WALTON OAKS

CITY OF ROCHESTER HILLS, OAKLAND COUNTY, MICHIGAN

City of Rochester Hills
Planning & Economic Development
Conditions and mark-ups noted throughout the plan set must be addressed prior to final approval.

JSC2022-0002
PSP2022-0005
Revision 4

DRAWN	MCS
DESIGNED	MCS
APPROVED	MCP
P.E. JOB No.	21-419
SCALE	1"=50'
S1	SITE PLAN

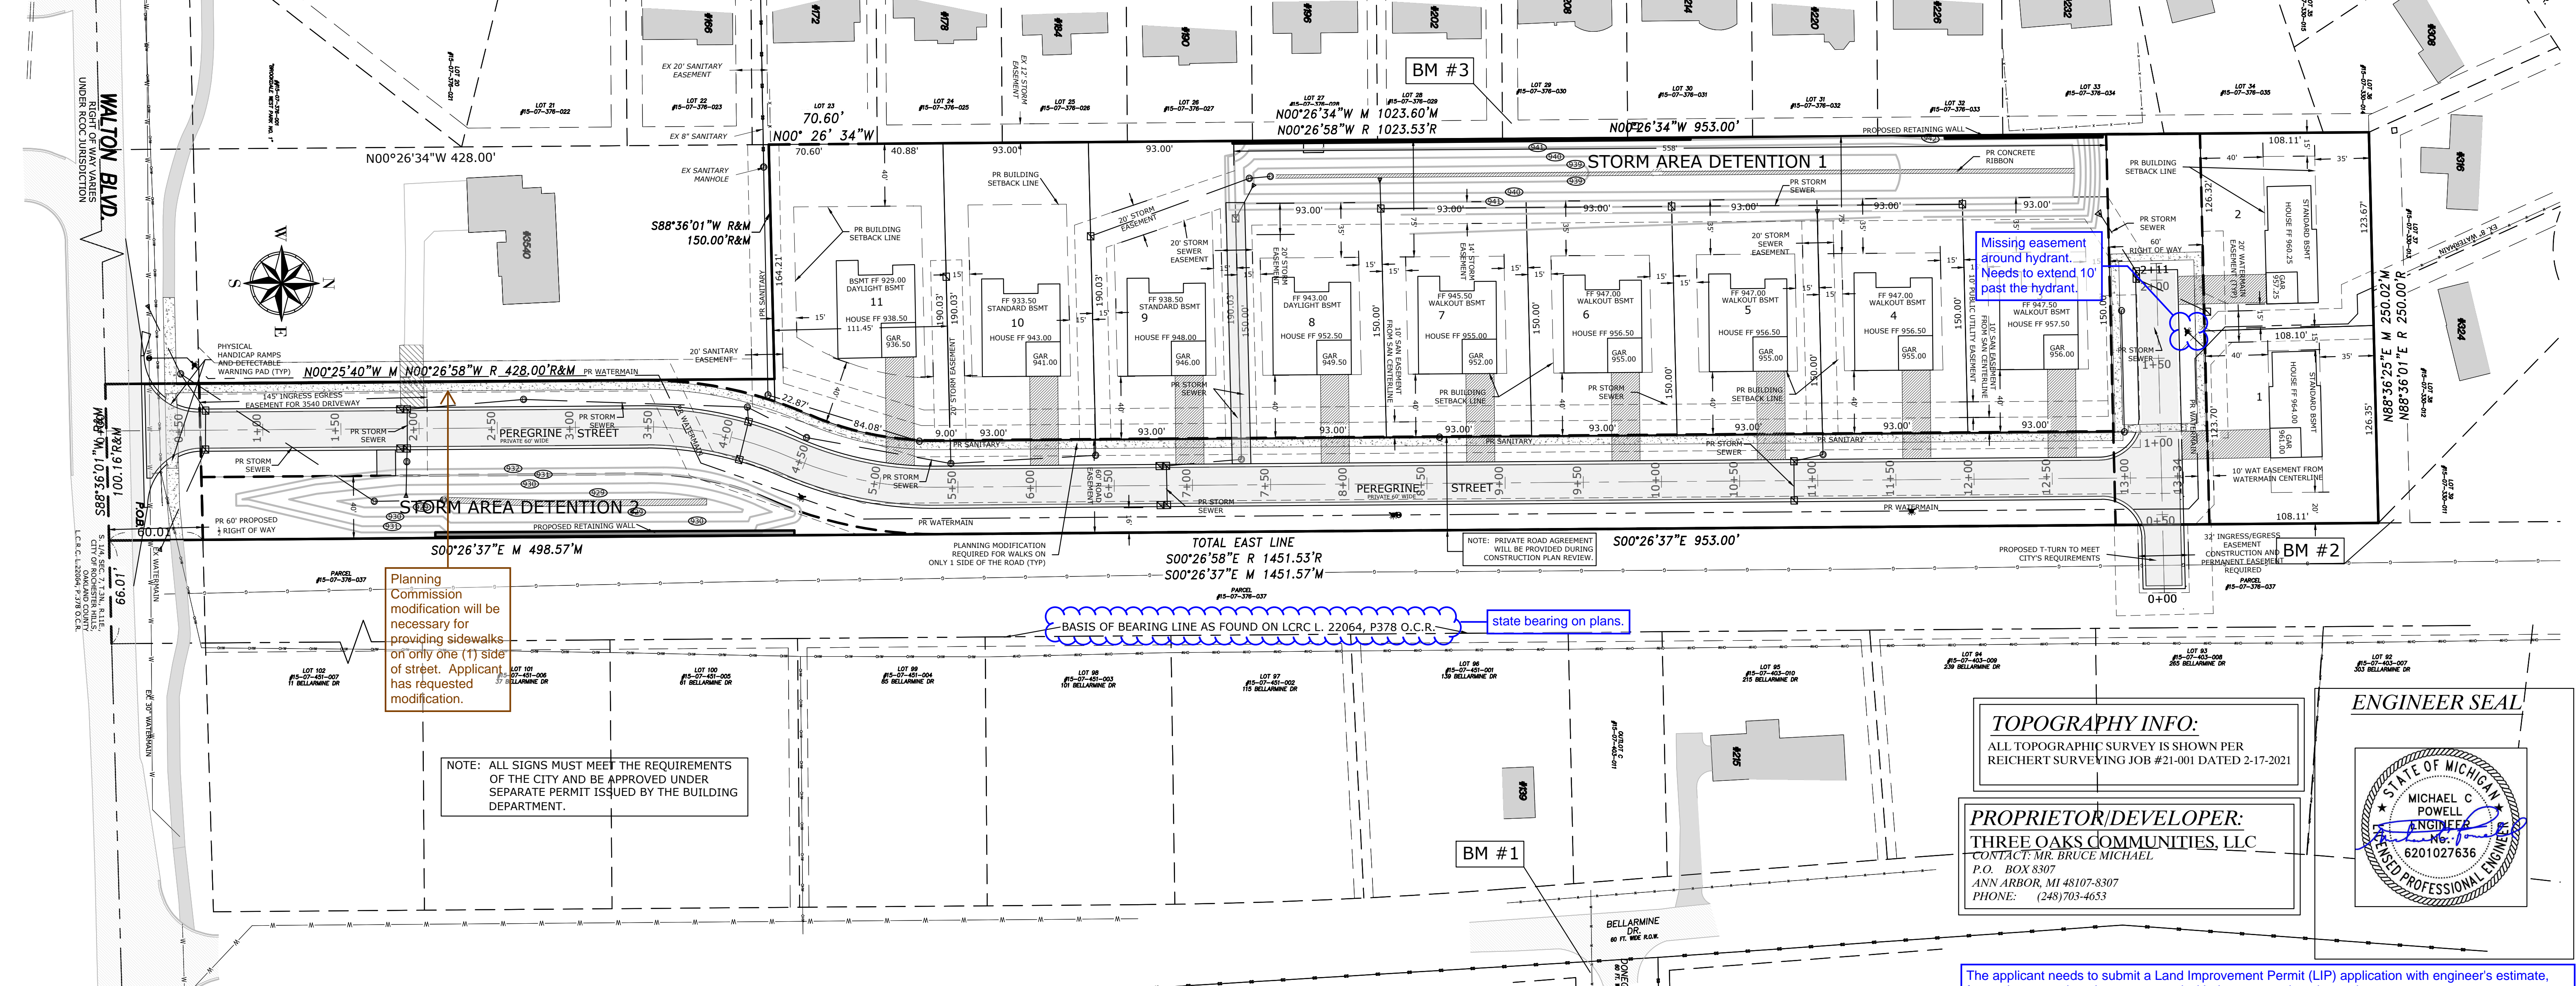
Planning Commission modification will be necessary for providing sidewalks on only one (1) side of street. Applicant has requested modification.

Missing easement around hydrant. Needs to extend 10' past the hydrant.

BASIS OF BEARING LINE AS FOUND ON LCRC L. 22064, P378 O.C.R. state bearing on plans.

DRAWN	MCS
DESIGNED	MCS
APPROVED	MCS
P.E. JOB NO.	21-419
SCALE	1"=30'
S2	SITE PLAN

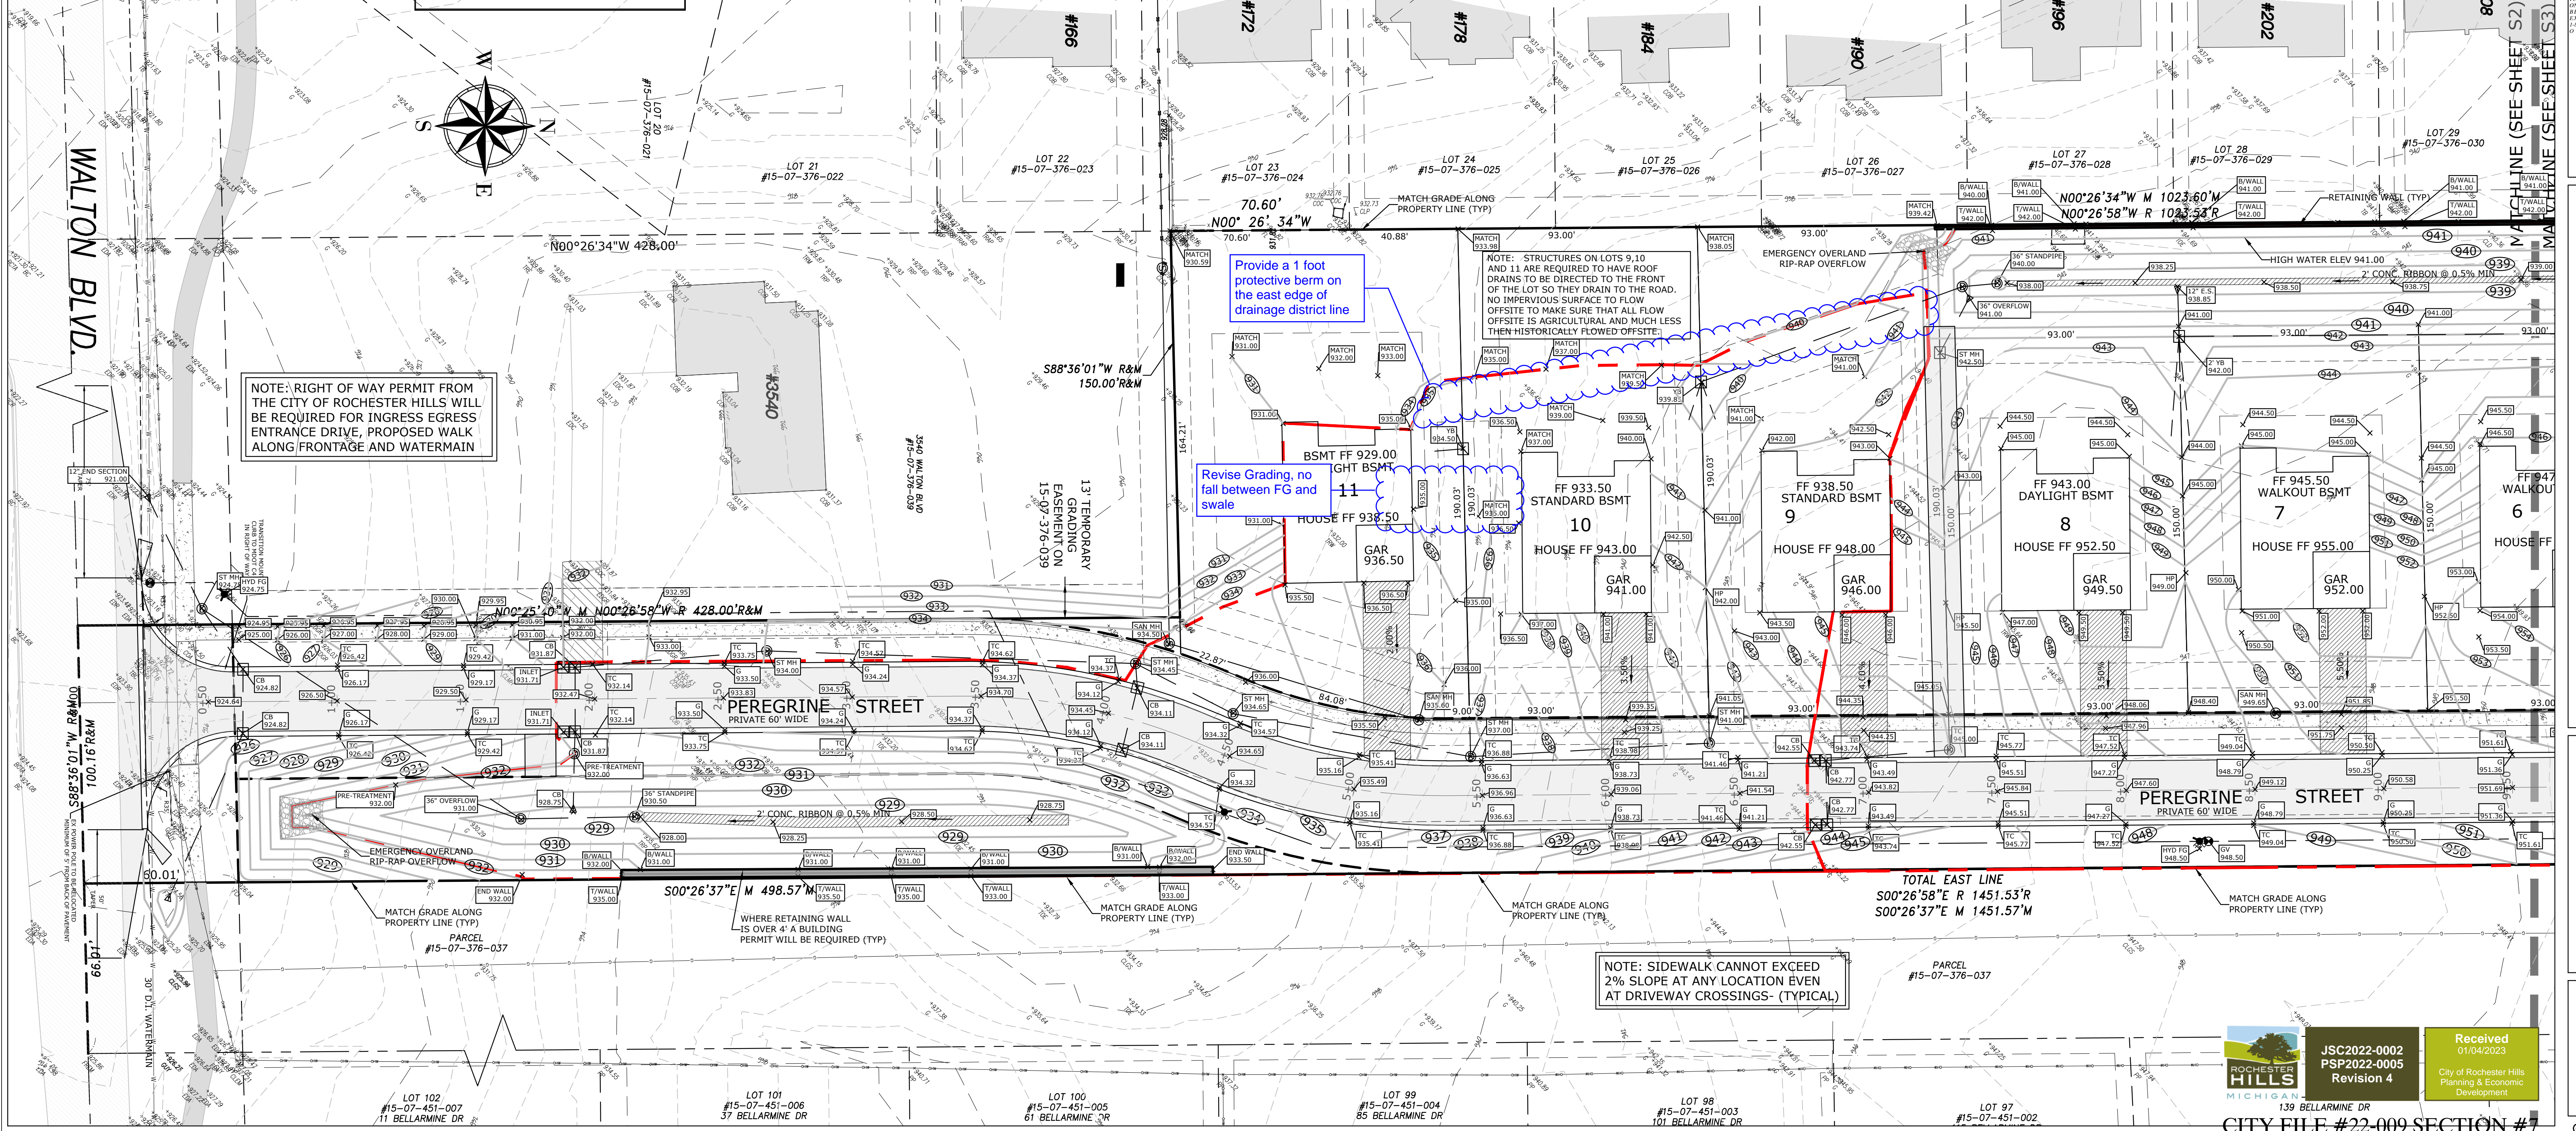
The applicant needs to submit a Land Improvement Permit (LIP) application with engineer's estimate, fee and construction plans to proceed with the construction plan review process.

DRAWN MCS
DESIGNED MCS
APPROVED MCP
P.E. JOB NO. 21-419
SCALE 1"=30'
33 SITE PLAN

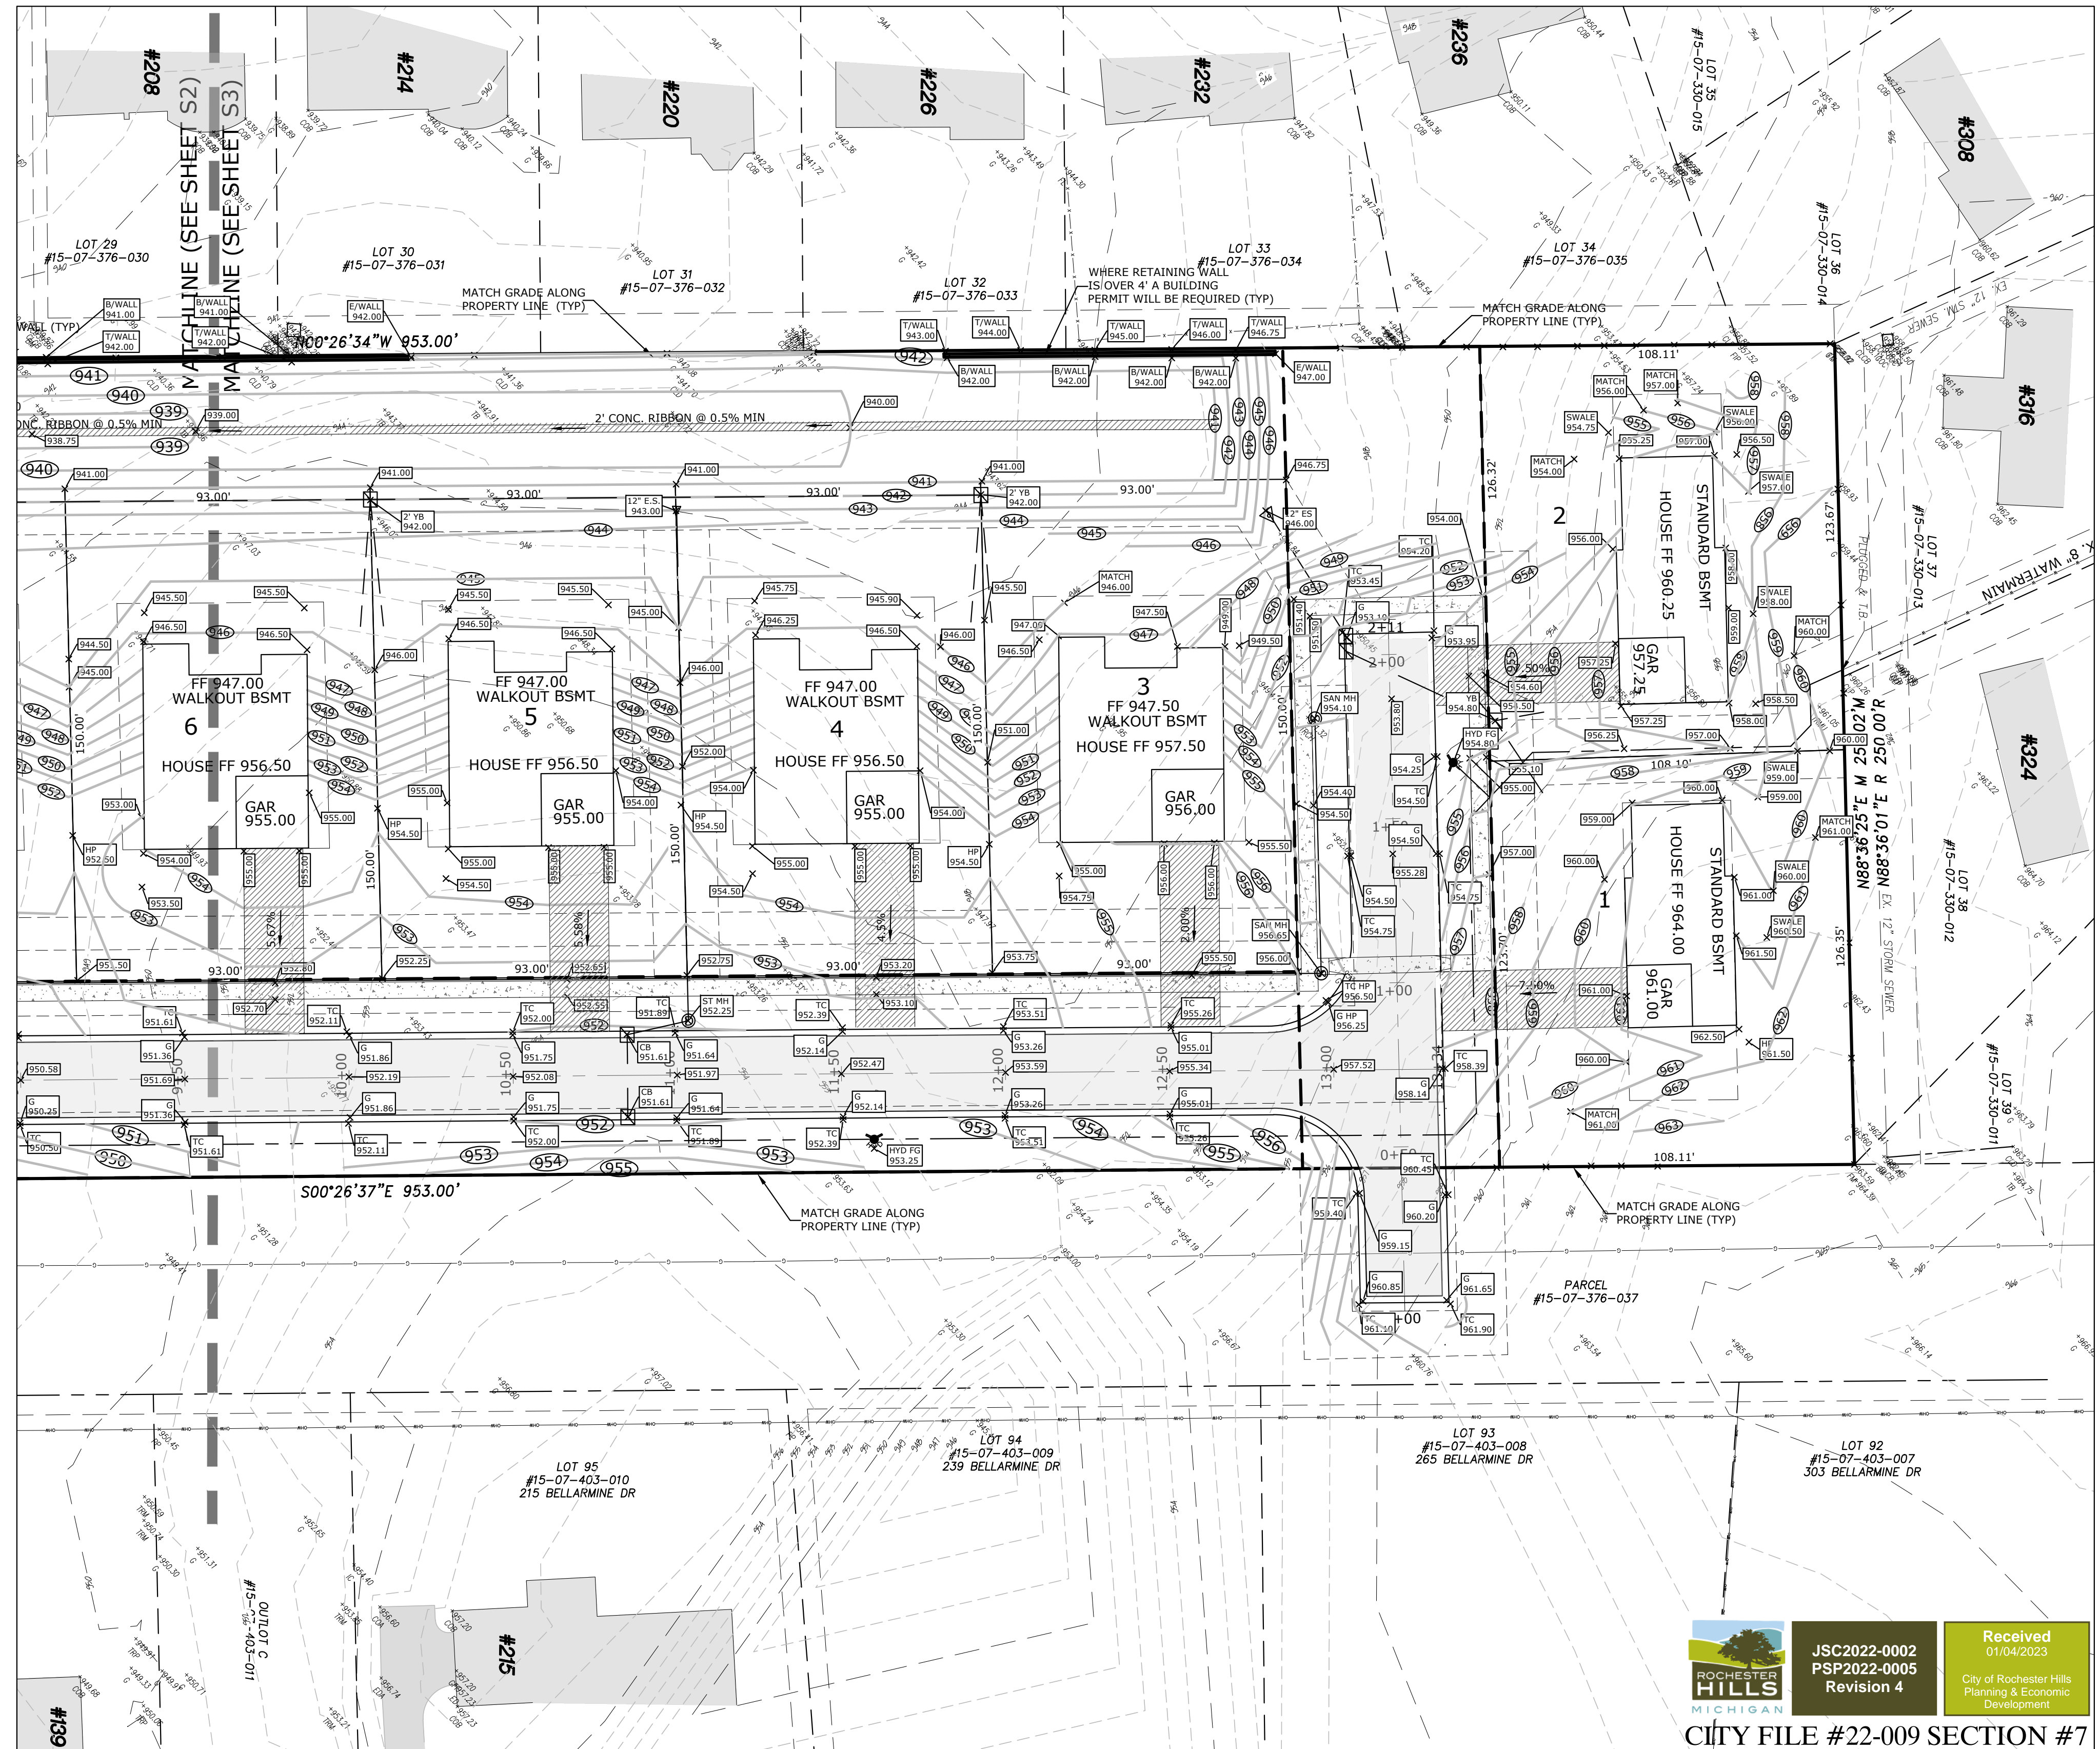
Provide a 1 foot protective berm on the east edge of drainage district line

Revise Grading, no fall between FG and swale
